Transitway Station Design Safety Audit – Analysis of Findings

Final Report

OC Transpo
City of Ottawa

September 28, 2021

FIGURE 2: Probability of Redirection When Striking a 150 mm Barrier Curb at an Approach Angle of 5°

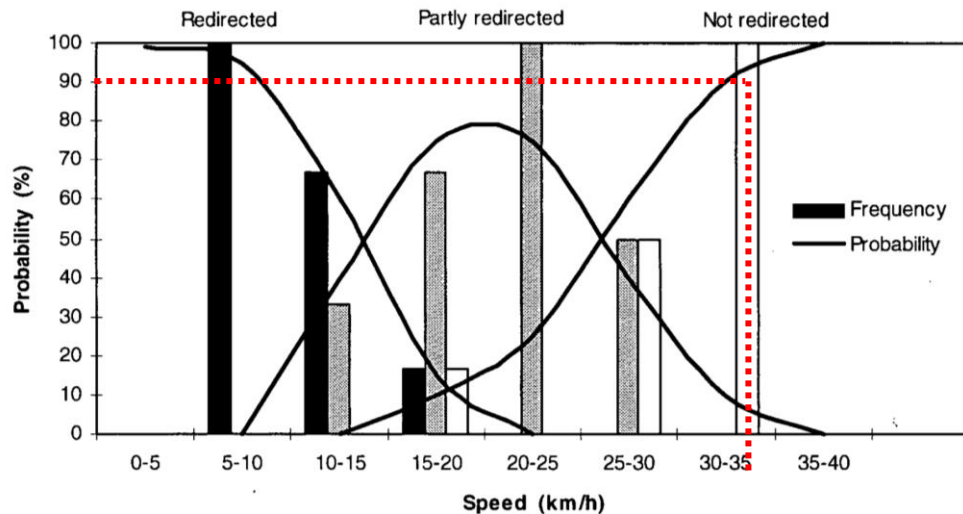
Auditor’s Suggestion: Replace the letdown curb on the approach end of the station platform with a 150mm high barrier curb. The letdown curb on the departure end of the station platform can remain. Note potential design guideline implication - locate curb letdown far side of station and curb height should be higher at BRT Stations, namely a raised platform 200mm (8”) to 250mm (10”) (reference to APTA BRT Stations and Stops Recommended Practice).

Whether a roadside curb is likely to redirect an errant vehicle, is dependent on many factors, including but not limited to, the curb height and shape, the angle of departure from the roadway, the vehicle speed at impact with the curb, and the vehicle specifications (mass, tire size, etc.). Full-scale tests on the redirection capabilities of 150 mm high barrier-type curbs indicates that these elements of the roadside have almost no ability to redirect errant vehicles at speeds above 26 km/h, regardless of the angle of departure (see Figure 2).⁶ Therefore, while the idea of replacing the depressed curb with a 150 mm barrier curb is intuitively appealing, the research indicates that this action is not likely to mitigate the identified safety issue.

It is recommended that OC Transpo take no action on relocating the service bay to downstream of the station due to the limited effectiveness of barrier curbs in redirecting errant vehicles. It is also recommended that, when the station is reconstructed, the guidelines for service bay placement and design conform to the prevailing best practices.

FIGURE 3: Severity Indices for Rock Cuts and Concrete Barriers

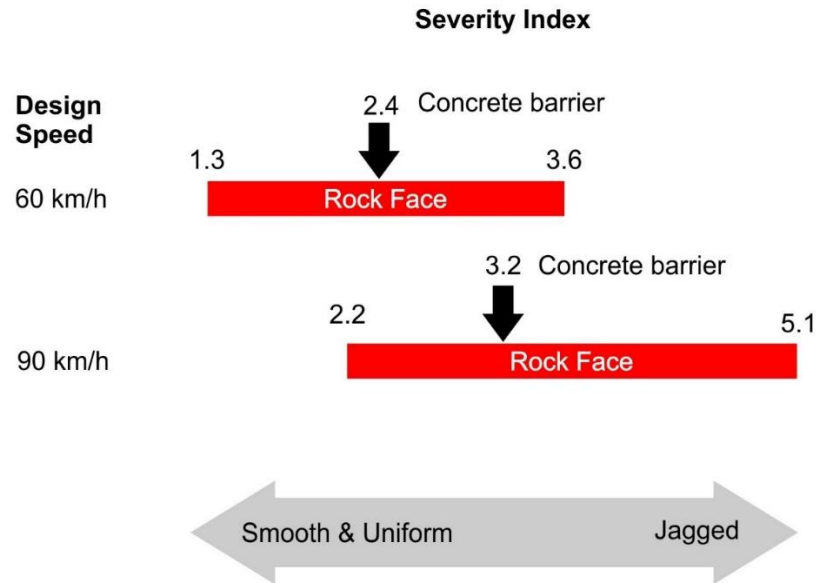
Auditor’s Suggestion: Install an appropriate length of need and taper of an anchored TL-3 F-Shape concrete barrier or a Cast-In-Place TL-4 F-shape concrete barrier. The barrier should be installed 1m offset from the edge line.

A jagged rock face increases the potential for higher severity crash in the event that an errant vehicle makes contact with the rock face. However, it is not axiomatic that an exposed rock face is a more severe hazard than a concrete barrier located 1.0 metres from the travelled way. According to the Roadside Design Guide the severity indices for rock cuts and concrete barriers are as shown in Figure 3.⁹

Whether the concrete barrier is a less severe hazard than the rock face is very much dependent on the smoothness of the rock face. The difference between smooth and jagged is not defined in the Roadside Design Guide. Moreover, because the proposed concrete barrier would be located closer to the Transitway, the barrier would result in a higher frequency of crashes than the exposed rock face. Hence, installing a traffic barrier may be detrimental to safety if crashes with the rock face are infrequent.

What can be concluded from the above information is that ensuring the rock cut is smooth and uniform is preferable to erecting a concrete barrier, from a crash severity and crash frequency perspective. The smooth and uniform rock cut has a lower severity index than a concrete barrier and would be located further from the Transitway.

It is recommended that OC Transpo review the rock cut at this location and conduct rock scaling and other maintenance to the rock face to provide as smooth a rock face as practicable. The cost and effort expended on this initiative should be commensurate with the fact that the Westboro station is to be decommissioned in the second quarter of 2022.

FIGURE 6: Luminance and Visual Function

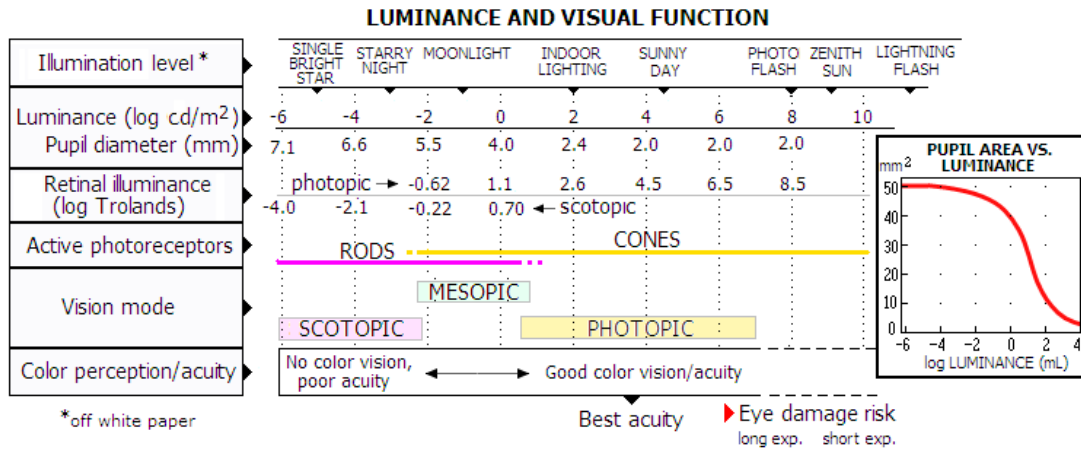
With respect to light adaptation, a shadow cast across the Transitway from a pedestrian bridge does not necessarily create a condition that results in visual impairment due to light adaptation. What matters in this regard is the magnitude of the change in the ambient light levels. While the road surface in the bridge's shadow will be markedly darker than the road surface in the bright sunshine, the change in the ambient light level is not as drastic because light from the sun is reflected off nearby surfaces, helping to illuminate the Transitway. More specifically, and in the simplest terms, light adaptation causes short-term visual impairment when an observer transitions rapidly from having to use photopic to scotopic vision (a rapid transition from light to dark) or vice versa (dark

to light). Different photoreceptors are used in light and dark conditions respectively, and a rapid transition can cause periods of temporary visual impairment as the eye switches from one type of photoreceptor to the other type (see Figure 6).

The ambient light in the shadow of the pedestrian bridge, even on the brightest day, is still likely to be in the range of typical indoor lighting. This being the case, operators on the Transitway would still be using photopic vision and visual impairment due to light adaption is not likely.
